# CITY PLAN COMMISSION STAFF REPORT

Barryview

CD-CPC-2024-00060  
Rezoning without Plan

CD-CPC-2024-00061  
Residential Development Plan

North  
 TREE PRESERVATION PLAN  
 SCALE: 1" = 100'

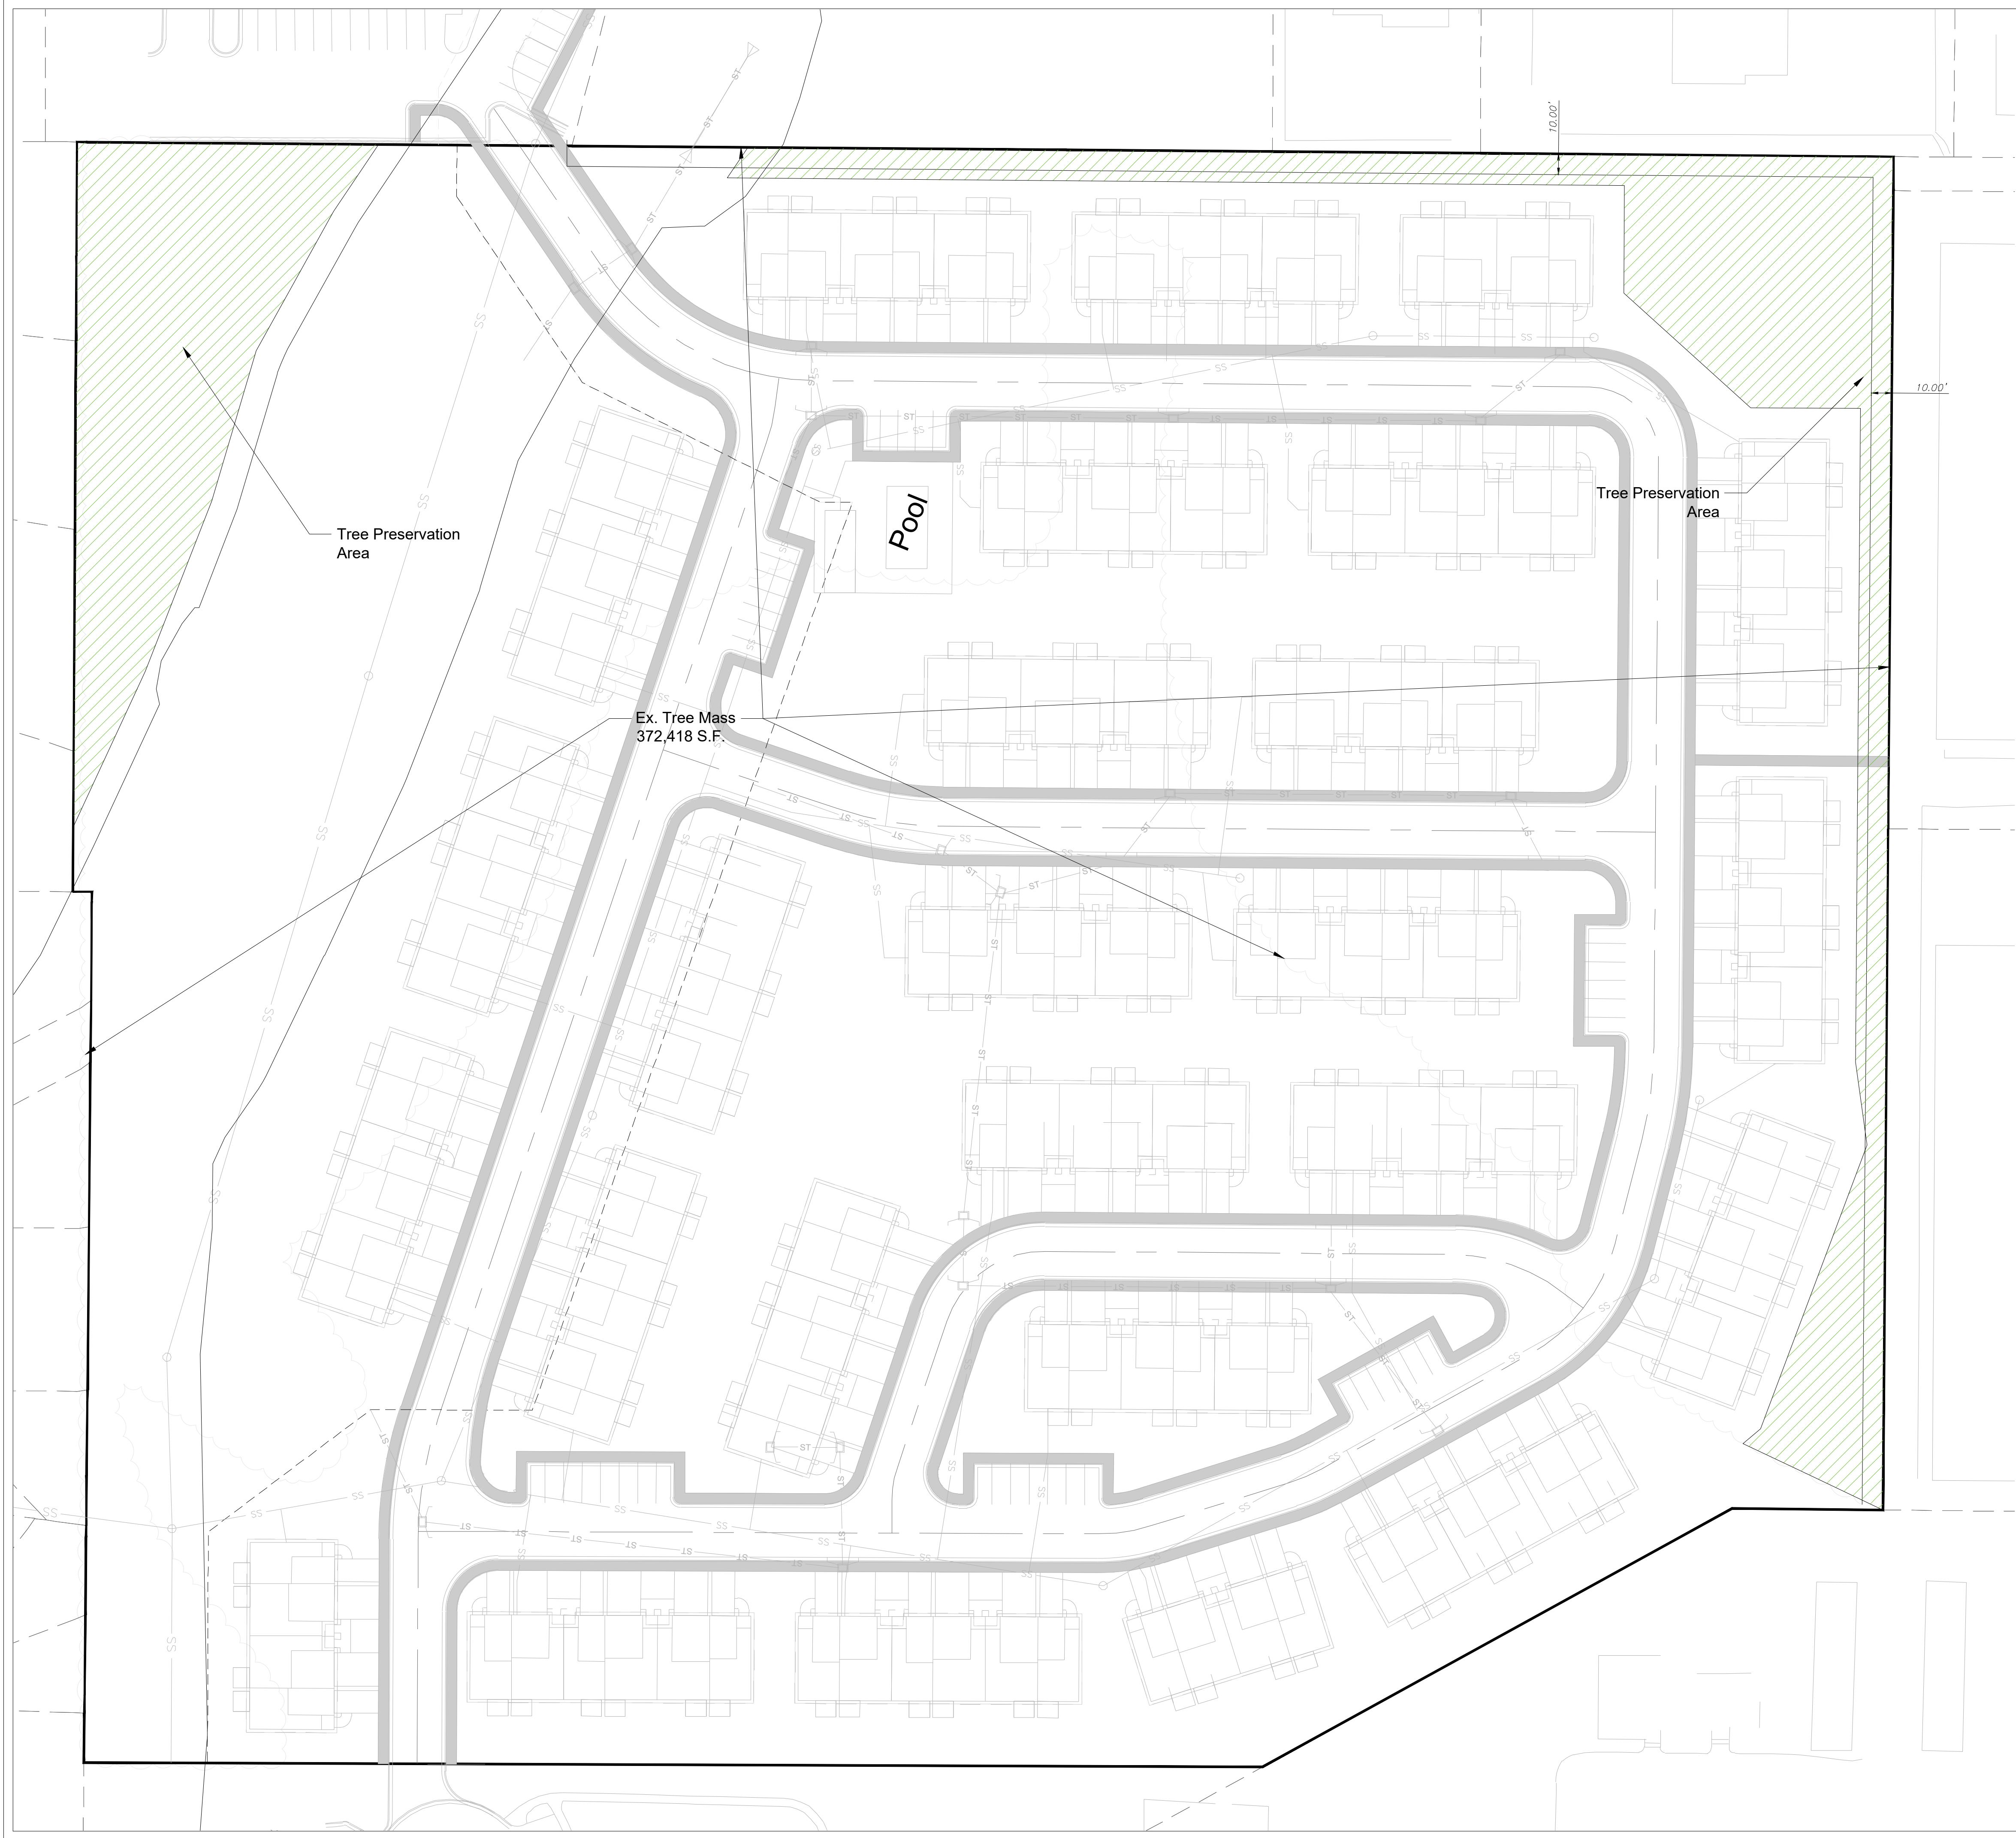
- Sheets L.100 and 101 show 3" calipers. Revise to 2" calipers as these are the maximum recommended by staff.
  - Show and label the location and size of existing and proposed public and private water mains and fire hydrants on the utility plan sheet. Show and label the master water meters and backflow preventers.

- Provide revised tree preservation plan with 2" caliper trees or total amount of payment in lieu.
  - Show detail of any proposed fence, including material and fence height.

OVERALL SIDEWALK PLAN

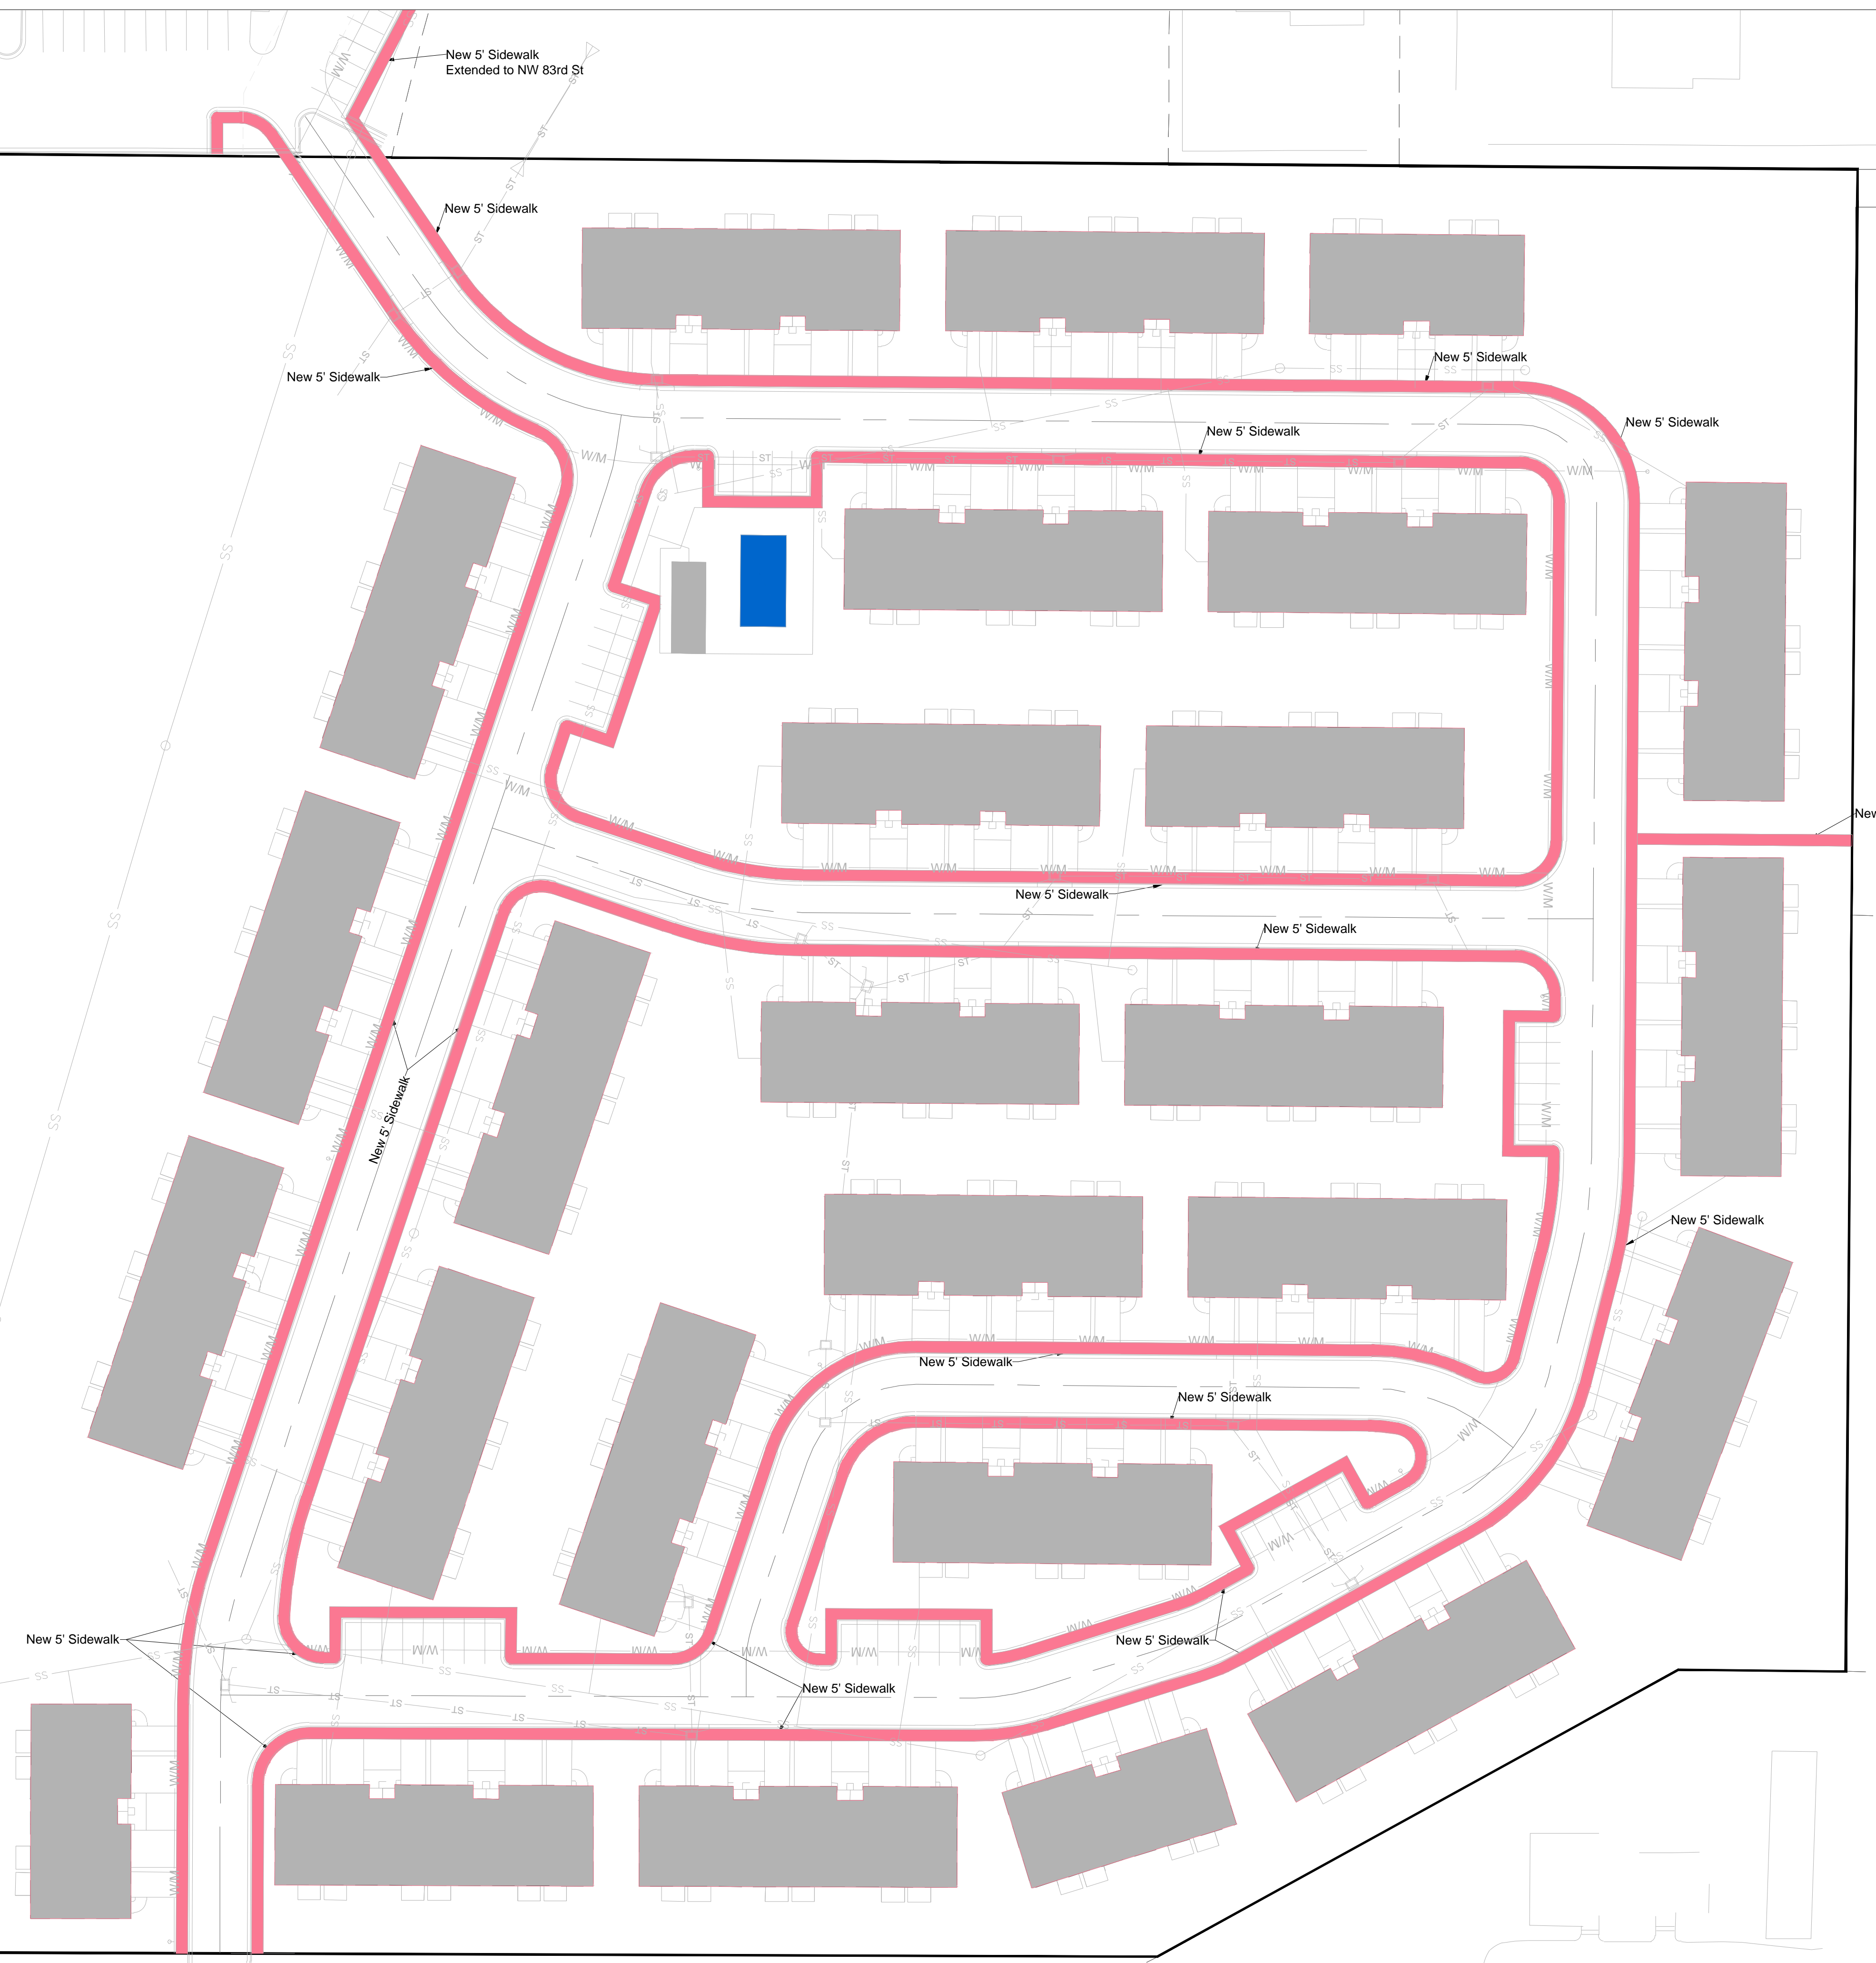
- Provide a sidewalk connection along access road all the way to NW 83rd St. I believe the sidewalk ends at the other lot being purchased for access.
